## Hansen Plat 1 – Major Preliminary Plat

- Applicant:** Don and Sherry Hansen (Developer & Property Owner) represented by Vic Piagentini with Associated Engineering Company of Iowa, Inc.
- Request:** Preliminary Plat Approval of a Major Subdivision Plat

## Hansen Plat 1

### Major Preliminary Plat

PRELIMINARY PLAT  
**HANSEN PLAT I**  
 SHEET 2 OF 2

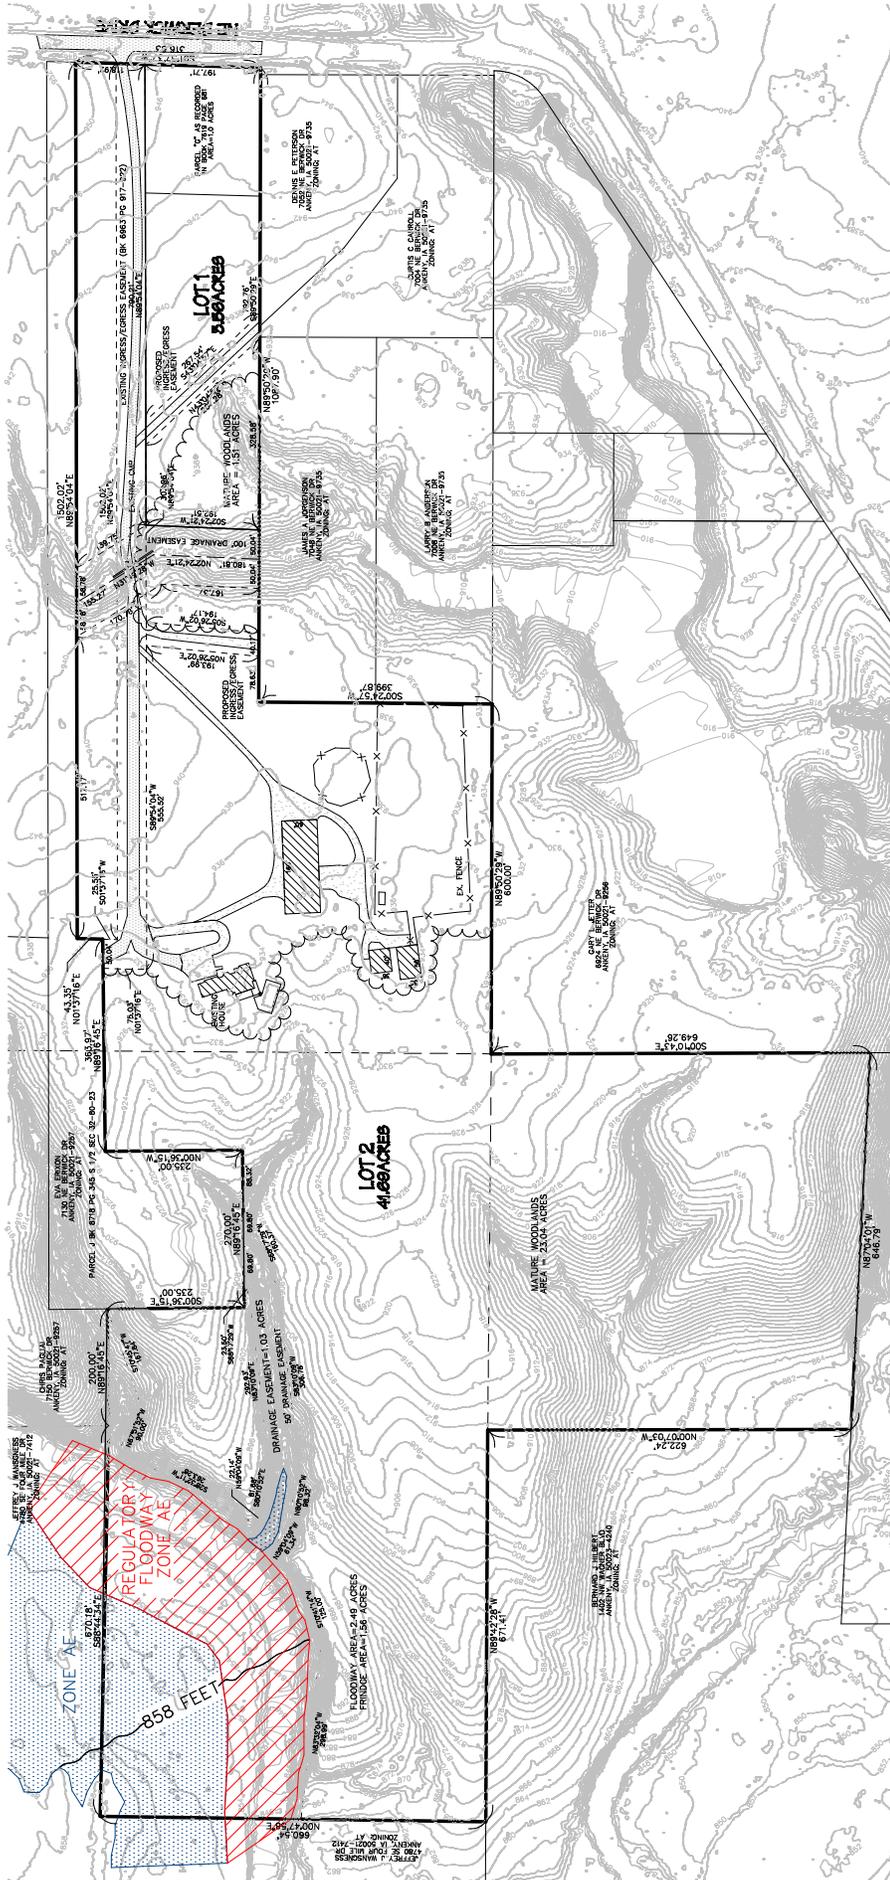
The reconfiguration of the parcels as shown on the proposed subdivision plat will require waivers from the following requirements:

- No residential block shall be longer than 1,320-feet or twelve (12) times the minimum lot width for the district, whichever is less, unless the Zoning Commission approves a longer distance in a Neighborhood Access Plan.
- Flag lots shall not exceed the flag lot size of three (3) acres for lots without public sanitary sewer.
- Flag lots shall not exceed the maximum flagpole length of four hundred (400) feet.

Staff has reviewed this plat for compliance with the Polk County Zoning and Subdivision Ordinances as a major subdivision plat submittal. The plat is considered a major subdivision due to the number of lots created in the  $\frac{1}{4}$ ,  $\frac{1}{4}$  Section and the requested waivers. Lot density, dimensions, frontage, access and potential waivers have been reviewed. Pending approval, re-submittals will be needed in order to address staff comments. At this stage, the commission's action would affirm, deny, or amend the overall plat layout. The current layout would require waivers from the block length requirement, flag lot size and flagpole length.

Staff recommends approval of the Preliminary Plat of Hansen Plat 1, as well as the requested waivers to the maximum block length standard, flag lot size and flagpole length. The topography of the subject property and adjacent properties, along with the drainageways in this area, would restrict the extension of connecting residential streets. Additionally, this area should be limited in development to preserve existing natural resources. The existing properties are proposing reconfiguration to allow for public frontage for an existing building right on a land locked parcel. Additionally, the existing homestead is already configured on a parcel with dimensions that create a flag lot greater than 3-acres.
